Service Bulletin

BULLETIN # 244

CP110, 115, 116, 121 & 122

REPLACEMENT FOR CP110-10/1N, ROTARY SW INCL DUST COVER&KNOB

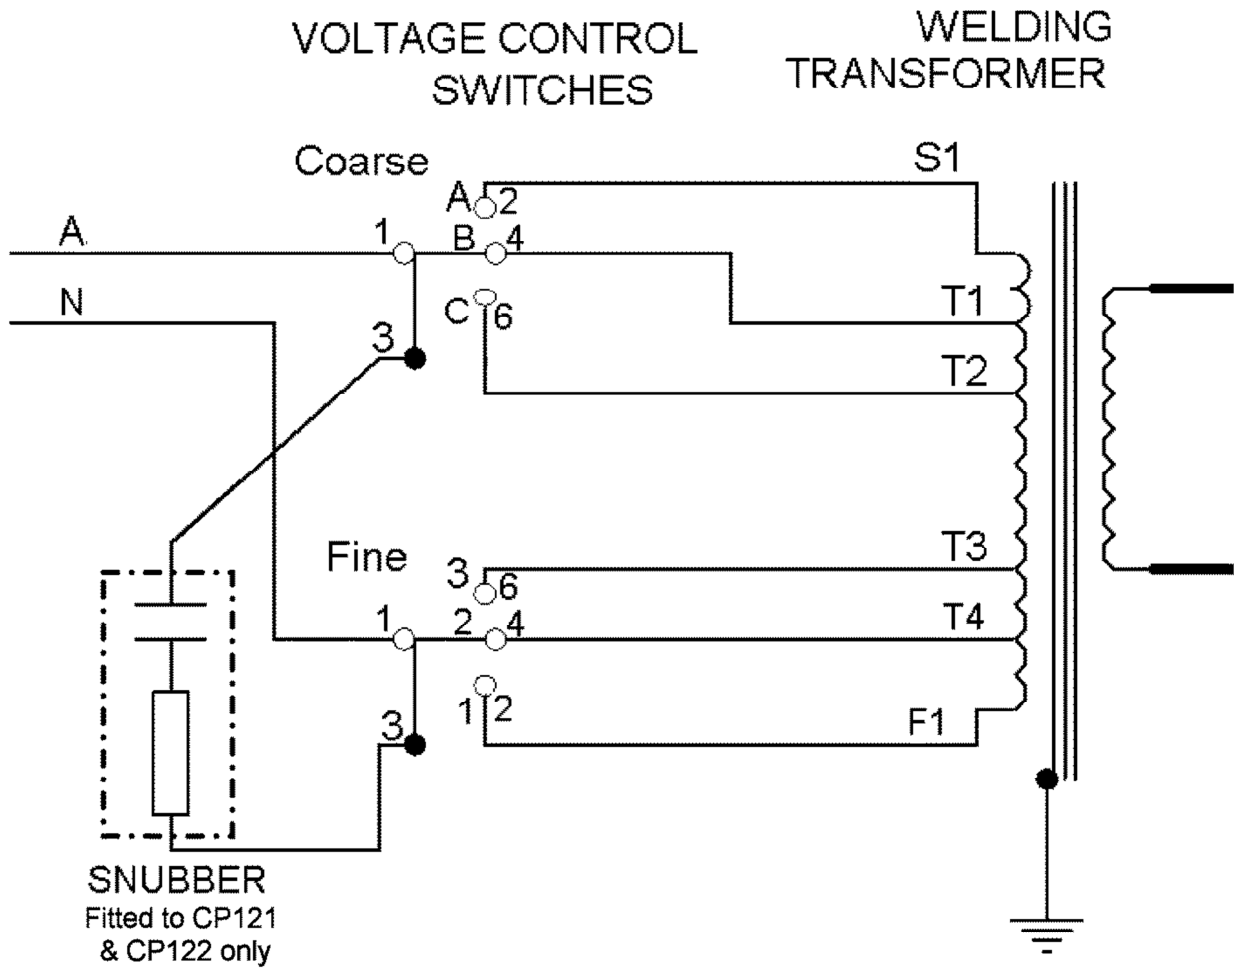
The voltage adjustment switch used in the Weldmatic 150, 175 and 175S (CP115, CP116, CP121 CP122-0 and CP110) is no longer available.

E0063, SWITCH ROTARY 3 POSITION may be used as a satisfactory replacement. The knob for E0063 is available as part number M0048, KNOB SWITCH.

- the new switch rotates 45 degrees per step, whereas the old switch moved 60 deg per step. This means that careful alignment is required when drilling mounting holes for the new switch to ensure that the knob indicates correctly.

- with the knob temporarily fitted to the switch shaft, turn the switch to its mid position. Note the orientation of the 2 switch mounting holes while the indicator on the knob is pointing to the middle switch position on the welder front panel (Coarse "B", or Fine "2"). Drill 2 new mounting holes, 4.5mm (3/16") diameter, 29mm (1 1/8") apart, in the front panel. The position of the holes must allow the indicator to point towards Coarse "B", or Fine "2" (as appropriate, depending on whether the coarse or fine switch is being replaced) when the switch is rotated to its middle position.

- secure the new switch to the front panel and fasten the knob with its screw. Check that the knob indicates correctly for all 3 positions. The new indicator will point to a position slightly short of the 2 extreme markings, however if the centre indication is accurate, then the 2 outer positions will quite satisfactorily indicate the correct selection.

- connect the wires as per diagram on page 2. The old switch had spade terminals, whereas the new switch has one spade terminal with the others being screw terminals. Suitable terminations will need to be provided on the transformer wires for these screw terminals.
